EPA REGION 8'S RESPONSE TO PETITION FOR REVIEW

Doc 001, EPA Dewey-Burdock Response to Public Comments,
including descriptions of changes from the 2017 draft to final UIC Class
III and Class V Permits, (November 24, 2020)

Response to Public Comments

Class III Area Permit No. SD31231-00000, Aquifer Exemption Decision

Figure A. Gott et al., 1974, Plate 2 showing the extent of the Dewey Fault and Structural Zone with the Dewey-Burdock Project Area superimposed.

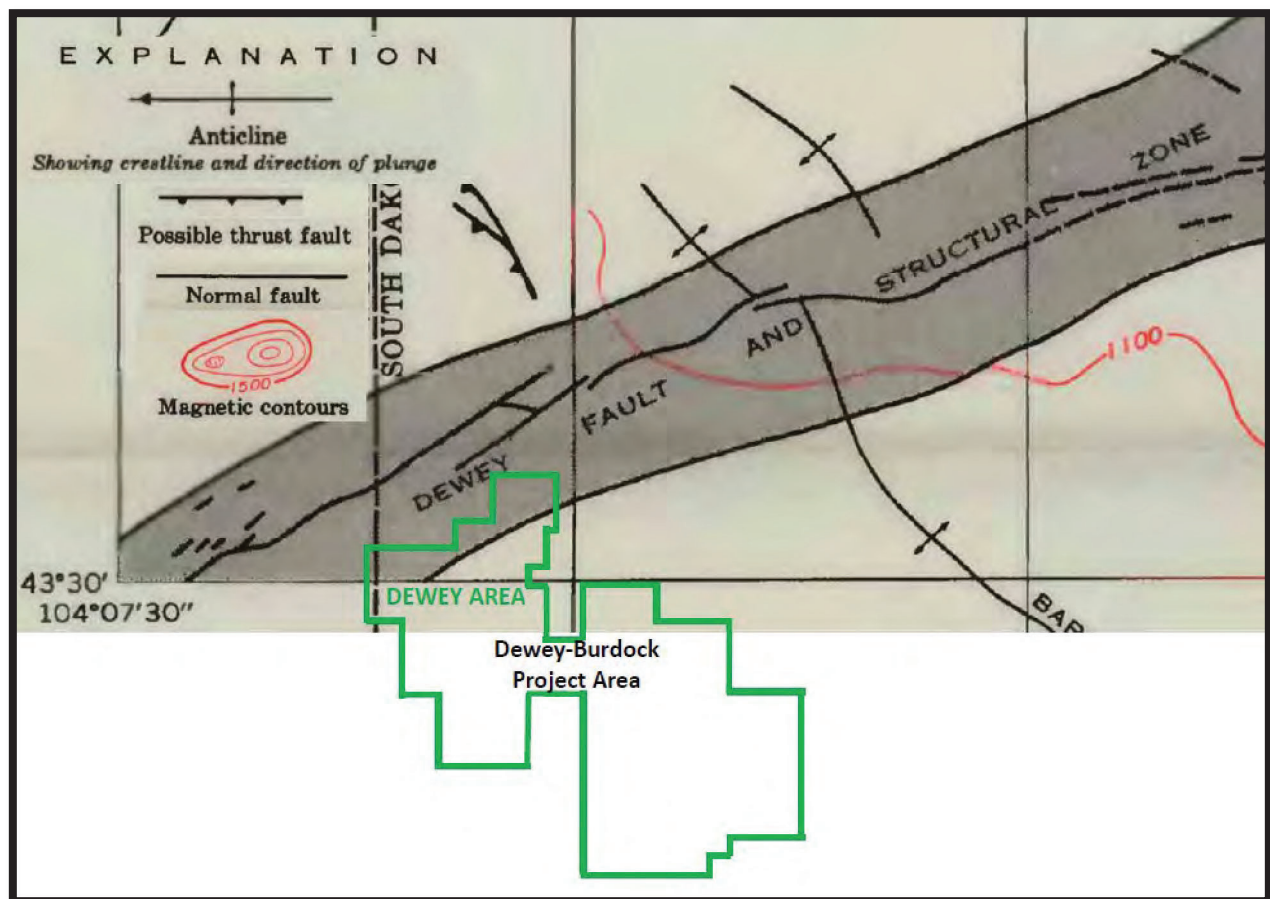
There is no evidence of the Dewey fault inside the project area. (Brobst, 1961, *Geology of the Dewey Quadrangle Wyoming-South Dakota*, USGS Bulletin 1063-B.) Brobst, 1961, describes the Dewey Fault in the Dewey quadrangle geologic report as the fault passing through the town of Dewey and refers to the fault located to the southeast without a name. Braddock, 1963, does not refer to more than one fault plane related to the Dewey Fault in the Geology of the Jewel Cave SW quadrangle report (Braddock, W.A., 1963, *Geology of the Jewel Cave SW quadrangle Custer County, South Dakota*, USGS Bull 1063-G). Gott, et al., 1974, includes both faults described by Brobst, 1961, in the Dewey Fault and Structural Zone. The boundaries of this structural zone are shown in Plates 2 and 4 of the Gott et al., 1974 report. The extent of the Dewey Fault and Structural Zone as defined by Gott in Plate 2 near the Dewey-Burdock Project Site is shown in Figure A. The Dewey-Burdock Project Site Boundary is superimposed on Plate 2. Although Gott shows the Dewey Fault and Structural Zone as extending into the northwestern edge of the Dewey-Burdock Project Site, there is no evidence of any fault inside the Project Area.

Figure B. Excerpt from Gott et al., 2001, Plate 4 showing features inside the Dewey-Burdock Project Boundary.

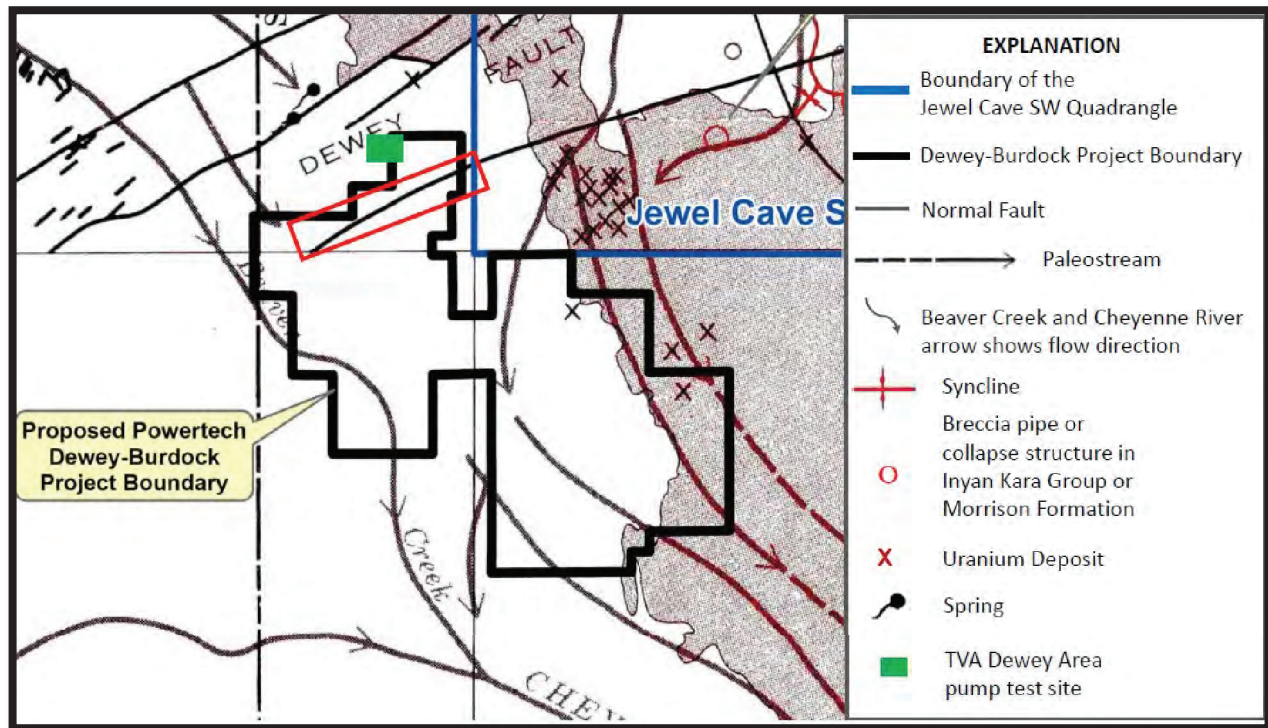
A commenter referred to Plate 4 from Gott et al., 1974, as the Gott fault map. Powertech used Plate 4 as a base map for Plate 6.24 of the Class III Permit Application and superimposed the Dewey-Burdock Project Boundary to show where the collapse features and breccia pipes identified in Gott et al., 1974, are located relative to the Project Site. Plate 6.24 shows that none of these features are located inside the Project Area. Figure B is an excerpt from Plate 6.24. The features shown inside the project boundary are Beaver Creek and paleostreams. The linear feature in the red box inside the Dewey-Burdock Project Area is the southeast boundary of the Dewey-Fault and Structural Zone shown in Plate 2.

EPA disagrees with the commenter's statement that the features in Plate 4 demonstrate that EPA failed to conduct the necessary physical surveys to confirm or deny the presence of these geological features. Based on the discussion above regarding the features identified in Plate 4 within the Project Area, there is no need for EPA to perform a physical survey because no disruption of confining zones in the currently proposed wellfield areas is indicated by the information in Plate 4.

Figure C. Dewey wellfield locations relative to the possible normal fault location in the Dewey-Burdock Project Boundary.

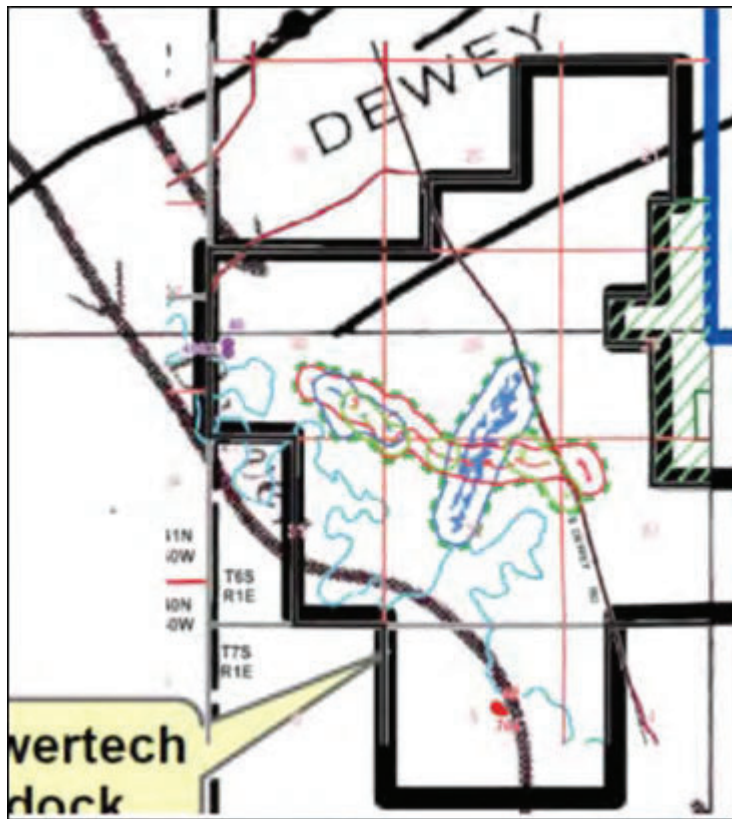
Figure C shows that the southeastern edge of the Dewey Fault and Structural Zone does not intersect the proposed wellfields in the Dewey Area, so it is not of concern for the currently proposed for ISR operations. The fact that the Dewey Fault and Structural Zone is located upgradient of the Dewey wellfields and the inward hydraulic gradient required for each wellfield will prevent ISR injection interval fluids from migrating to the location of this zone. If Powertech proposes future wellfields in this area, correlation of drillhole data in the area would identify any offset of geologic strata caused by the presence of a fault.

Figure D. Potentiometric surface contour maps of the Fall River and Chilson aquifer from Figures 5.2 and 5.3 of the Class III Permit Application.

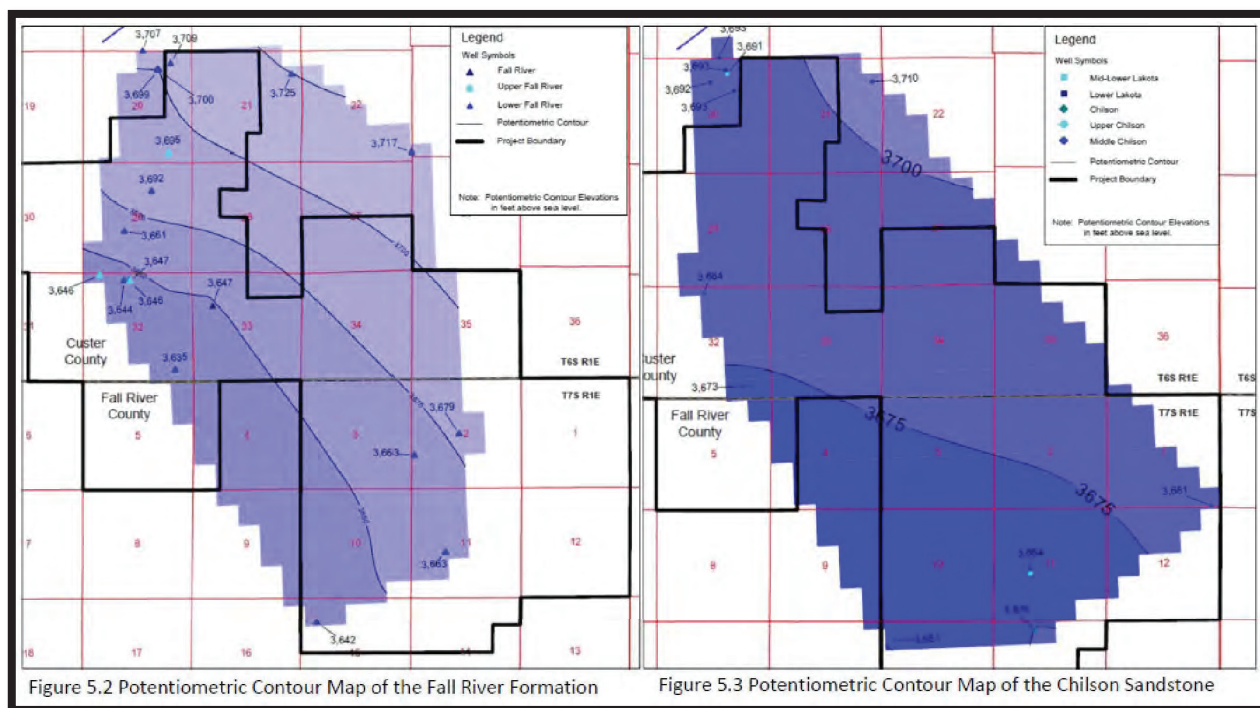
EPA disagrees with the interpretation that the potentiometric surface of the Fall River aquifer and the Chilson aquifer being at similar elevations in the vicinity of wellfields 6, 7 and 8 indicates leakage through the Fuson confining zone in this area. Figure D shows the potentiometric surface contours of the Fall River and Chilson aquifer based on water level measurements in wells completed in each aquifer.

These maps show that the potentiometric surface of the Fall River aquifer is at a higher elevation than that of the Chilson in the northeastern portion of the project area. The Chilson aquifer potentiometric surface is at a higher elevation than that of the Fall River aquifer in the southwestern portion of the project area. At some point these potentiometric surface elevations are at the same elevation, as demonstrated by the cross-sections shown in Plates 6.13 and 6.14 of the Class III Permit Application. EPA concludes that this is the reason for the similarity in elevation of the Fall River and Chilson potentiometric surfaces in the vicinity of Burdock Wellfields 6, 7 and 8.

Figure E. Areas of the Inyan Kara Group aquifers approved by this Record of Decision.

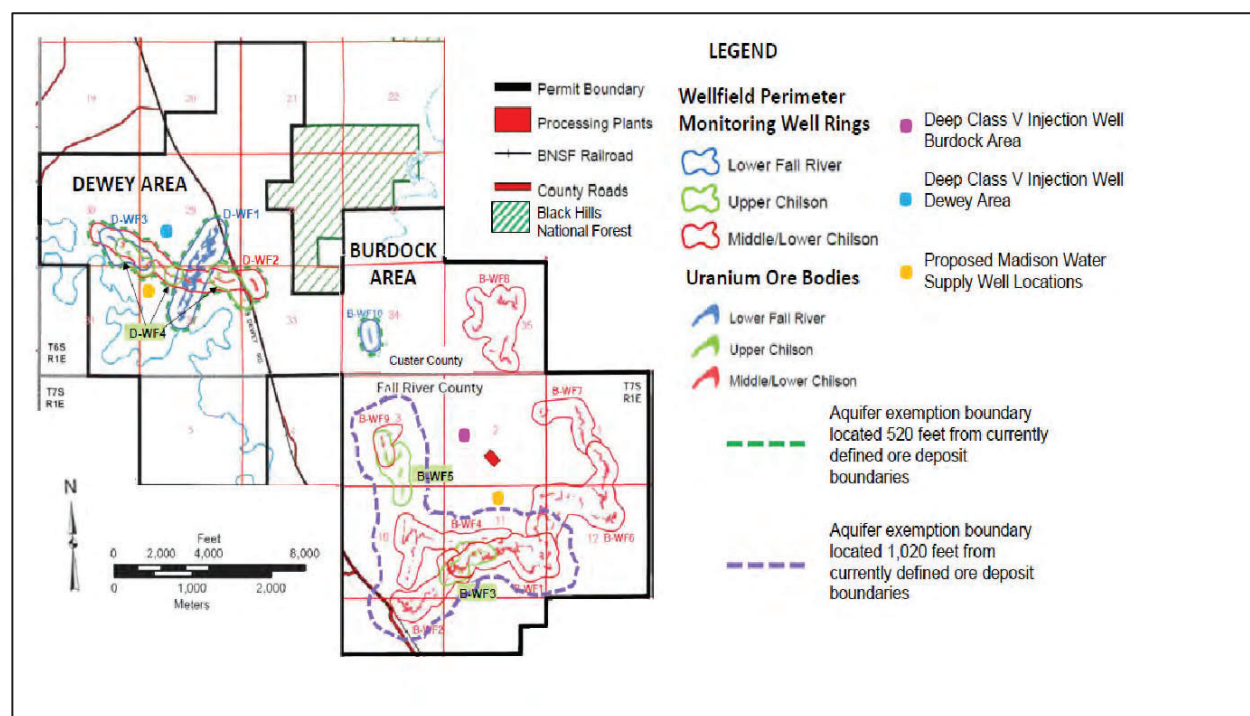
Powertech requested an expanded AE area to accommodate additional ore resources identified after the Class III Permit Application was submitted. EPA reviewed the Preliminary Economic Assessment reports developed by consultants documenting independent audits of mineral resource estimates at the Dewey-Burdock Project Site and determined that the commercially producible ore resource boundary had expanded in Burdock Wellfields 1 through 5, 9 and 10 since Powertech submitted the Class III Permit Application, justifying expanding the AE boundary for these wellfields. However, the commercially producible ore resource boundaries had not expanded for the other wellfields, so EPA did not expand the AE boundaries for these other wellfields. Because Powertech needs to do additional work to demonstrate that the potentiometric surfaces in Burdock Wellfields 6, 7 and 8 are able to sustain adequate monitoring of ISR operations in the overlying Upper Chilson aquifer, EPA is postponing approval the aquifer exemption in the area of Burdock Wellfields 6, 7 and 8 until Powertech performs further aquifer testing in that area.

Figure F. Minnelusa aquifer groundwater flow direction map from Figure 17, Driscoll et al., 2002.

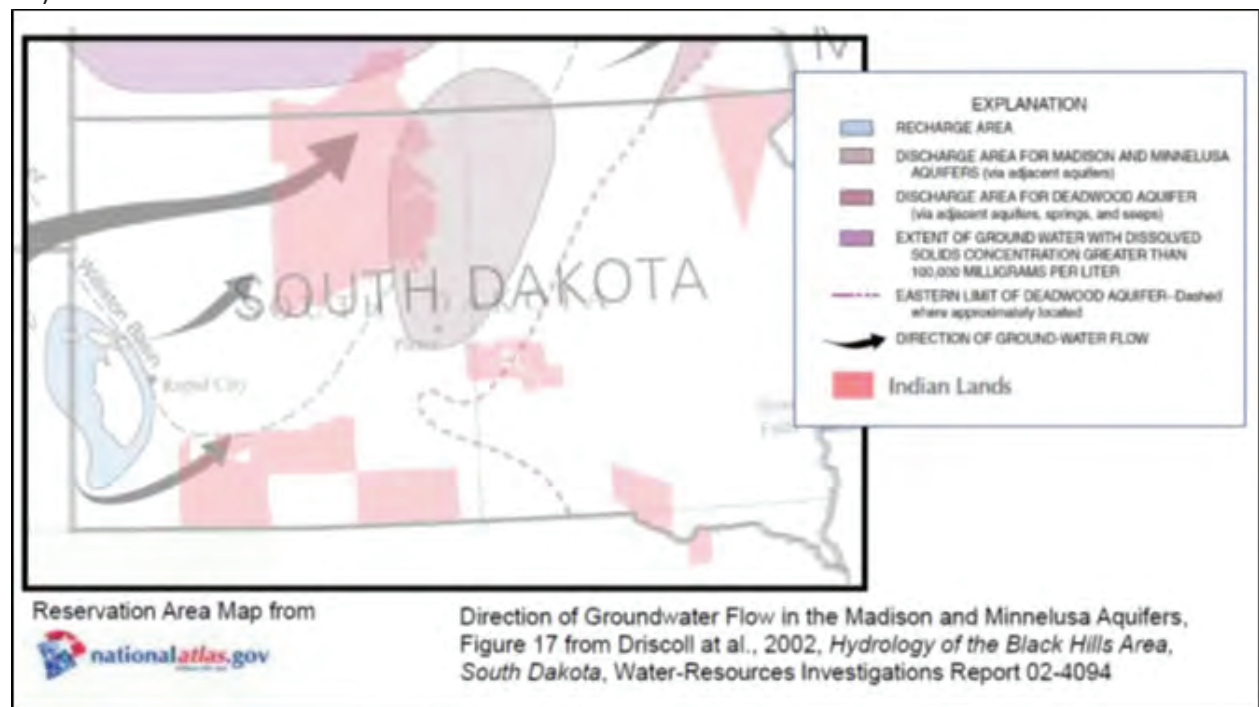
EPA investigated groundwater flow directions in the Minnelusa aquifer at the Dewey-Burdock Project Site and at the springs, such as Cascade Springs, south of the Black Hills. Figure F is a groundwater flow direction map from Figure 17 in Driscoll et al., 2002. This map shows the direction of groundwater flow in the Minnelusa aquifer from its recharge area in the Black Hills to a discharge area located at the eastern edge of the Cheyenne River Reservation. As shown in the map in Figure F, the authors hypothesize that the Minnelusa aquifer groundwater flows from the Dewey-Burdock site and flows around the southern end of the Black Hills toward the Williston Basin. (Driscoll, D.G., et al., 2002, *Hydrology of the Black Hills Area, South Dakota*, USGS Water-Resources Investigations Report 02-4094 at 22)

Figure G. Minnelusa aquifer potentiometric surface elevation contours in the area where springs occur south of the Black Hills (from Sheet 2, Strobel et al., 2000)

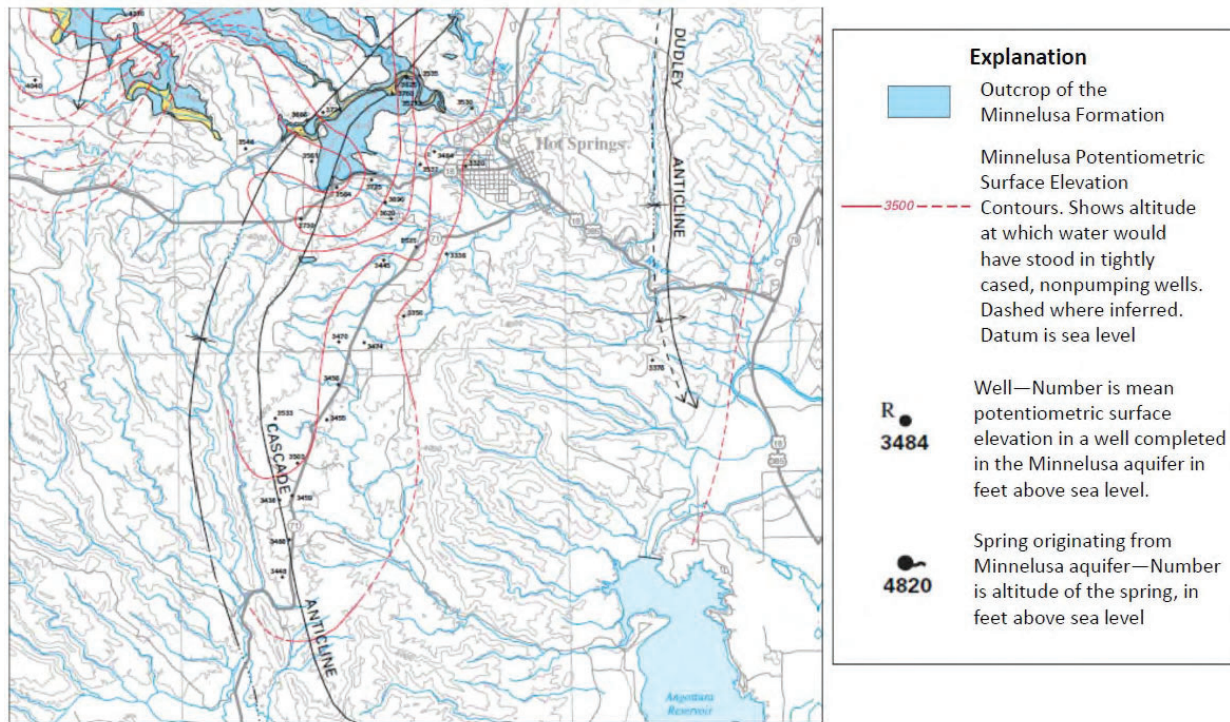
Figure G is the area where springs, including Cascade Springs, are located south of the Black Hills, excerpted from Sheet 2 of Strobel et al., 2000. The red lines show the potentiometric surface elevations based on wells completed in the Minnelusa and springs flowing from the Minnelusa. The potentiometric surface contours are deflected southward along the Cascade anticline where the Minnelusa and other geologic strata are raised in elevation. (Strobel et al., 2000)

Figure H. Elevation of the Minnelusa Formation top surface (Source: Sheet 2 of Carter and Redden, 1999)

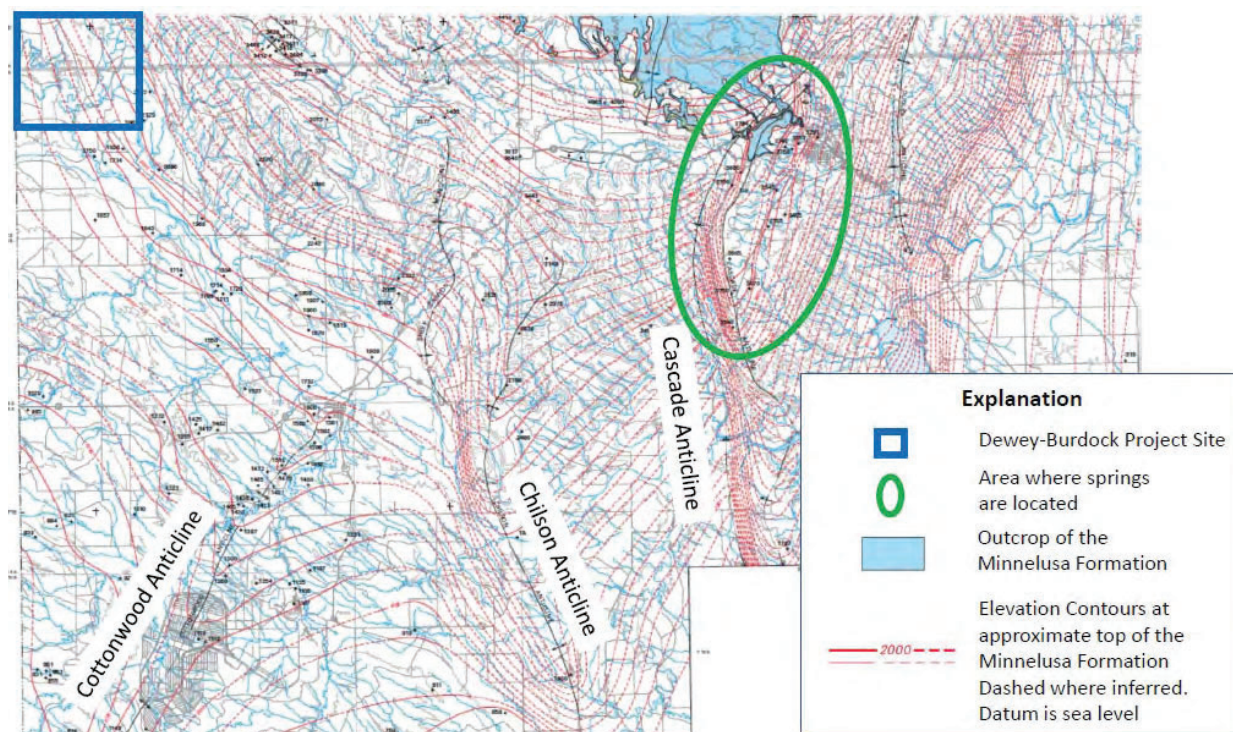
Figure H shows the area south of the Black Hills, excerpted from Sheet 2 of Carter and Redden, 1999. (Carter, J.M. and Redden, J.A., 1999, *Altitude of the Top of the Minnelusa Formation in the Black Hills Area, South Dakota*, USGS Hydrologic Investigations Atlas HA-744-C, Sheet 2) In this figure the red lines are elevation contours along the top of the Minnelusa Formation. The springs shown in Figure G are located inside the green oval. Based on the elevation of the top of the Minnelusa Formation shown in the area where springs occur south of the Black Hills, the top of the Minnelusa Formation is at a higher elevation at this location than at the Dewey-Burdock Project Site. Figure H shows how the Cottonwood, Chilson and Cascade anticlines affect the Minnelusa Formation elevation. The Class V injectate from the Dewey-Burdock site would have to flow uphill to reach the location of these springs. Based on the potentiometric surface contours in Figure G, the flow path of Class V injectate would be deflected to the south by the Chilson and Cascade anticlines and would have to flow uphill to reach these springs where Minnelusa and Madison groundwater flows to the surface.

Figure I. Locations of springs emanating from or passing through the Minnelusa aquifer, from Figure 29 of Naus et al., 2001.

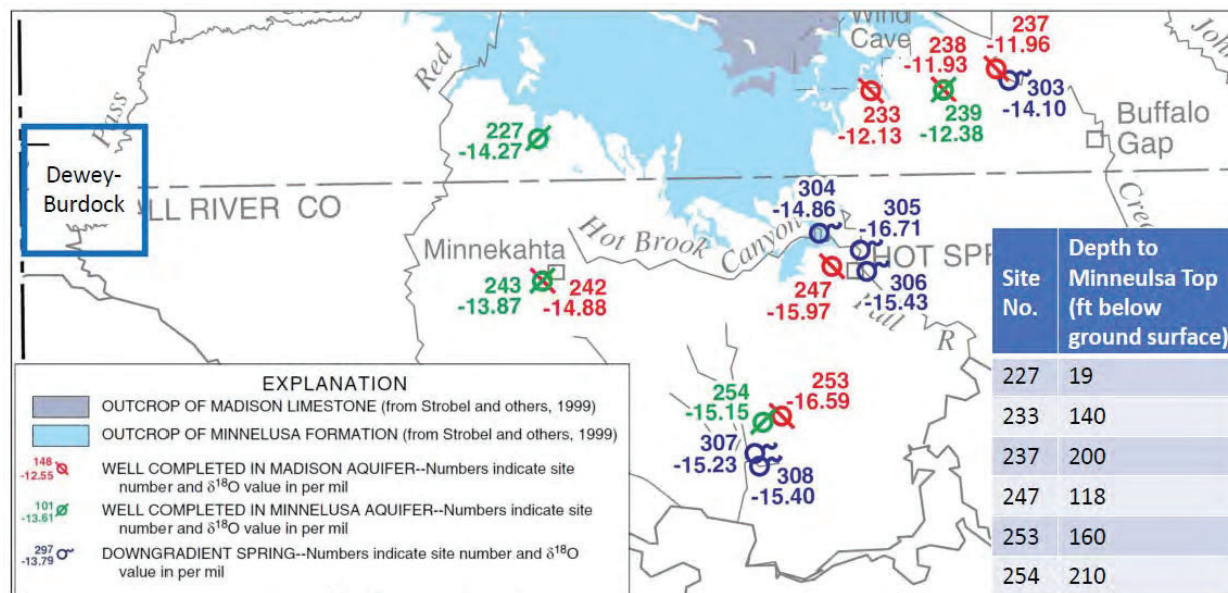
EPA reviewed water well logs in the area near the springs flowing from the Minnelusa and Madison aquifers. Figure I shows locations of Minnelusa (green) and Madison (red) wells and springs. The blue table in Figure I shows the depth to the top of the Minnelusa Formation in the logs for wells shown in Figure H. The springs occur where the top of the Minnelusa aquifer occurs closer to the ground surface. For example, at the location of the springs shown in Figure H the top of the Minnelusa is approximately 200 feet or less below ground surface, based on nearby private well logs.

Based on this analysis, EPA concludes that the Class V injectate will not contaminate the Madison aquifer and will not reach the area where the artesian springs are located.
